Subject: April 30, 2009 Response to EPA Letter dated March 12, 2009  
*Disapproval and Notice of Deficiencies, Draft Project Operations Plan,  
Olin Chemical Superfund Site, Wilmington, Mass*

**RESPONSE TO USEPA DEFICIENCIES AND COMMENTS ON THE  
DRAFT PROJECTS OPERATIONS PLAN  
DATED MARCH 12, 2009  
OLIN CHEMICAL SUPERFUND SITE; WILMINGTON, MA**

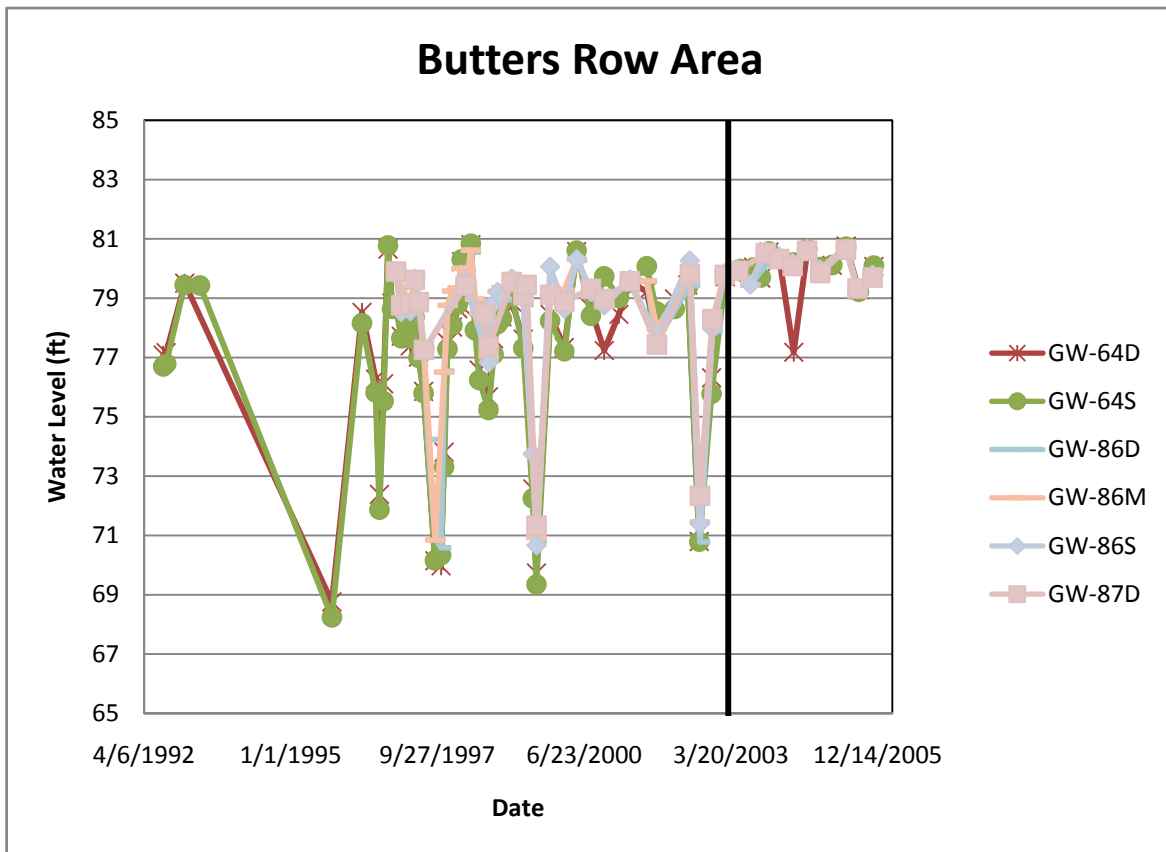
- Three new bedrock wells in the Maple Meadow Wetland Area adjacent to 3 existing well clusters where the deepest wells show elevated NDMA, chloride, and ammonia. At GW-83D (new well #5); GW-85D (new well #6); GW-87D (new well #7), Geomega concluded saddle effective barrier and DAPL solutes not being transported through bedrock to the western bedrock valley.

- A new deep overburden well or bedrock well between MP-3 and MP-4 (new well #8) where chloride, ammonia, NDMA were all elevated.
  - A bedrock well (new well #9) adjacent to Chestnut Street #1 where low levels of NDMA have been previously detected.

- A bedrock well (new well #10) adjacent at Butters Row #1 where low levels of NDMA have been previously detected.
  - Shallow or point driven wells in the wetlands adjacent to Maple Meadow Brook to evaluate changes in ground water/surface water relationships and better define the existence and location of the ground water divide and therefore background sampling locations. Although the previous ground (and surface) water data is useful in determining trends in water quality, some historical data may not be relevant because the 5 municipal wells have been taken off line and groundwater now likely discharges into the wetland.

**Response:** *Subsequent to the issuance of this letter by USEPA, Olin, and USEPA held discussions on March 19, 2009, and April 15, 2009, concerning the number and locations of wells to be proposed in the RI WP. Olin will propose well locations as discussed in the April 15, 2009, conference call to address the first six bullets in this comment (Section 6.1 and Figure 6.1-2 in the FSP).*

*When Olin conducts the first round of surface water sampling in the MMB wetland, three drive point piezometers will be installed by hand (Section 6.3 of the FSP). One will be installed within or adjacent to the stream channel of Sawmill Brook near surface water location MMB-SW/SD5, the second adjacent to the stream channel of MMB near surface water location MMB-SW/SD2, and the third adjacent to the MMB stream channel after the confluence of Sawmill Brook and MMB near surface water location MMB-SW/SD1. The water level within the piezometer will be measured and compared to the surface water level outside the piezometer to determine the relative gradient between the two water levels.*

*Olin has compiled historical water level information to assist understanding the response of the MMBA to pumping and non-pumping conditions. Data from several wells in the Butters Row Area are presented graphically below. Historical water level data from MMB indicates that only a small*

change in maximum groundwater levels has occurred since cessation of pumping of the town wells (shown by the vertical line in the graph below). The data also show that annual periods of deeper drawdown occurred in the aquifer in the past in response to municipal well pumping in late summer months (August and September) during periods of expected low recharge and higher water demand. Since cessation of pumping, the groundwater levels in this portion of the MMBA have increased approximately one foot, but are within the historical range of data. The increased groundwater levels would indicate a more active discharge of groundwater discharge to surface water. It would also indicate that shallow depth groundwater and surface water contributed to the municipal wells when they were operated.
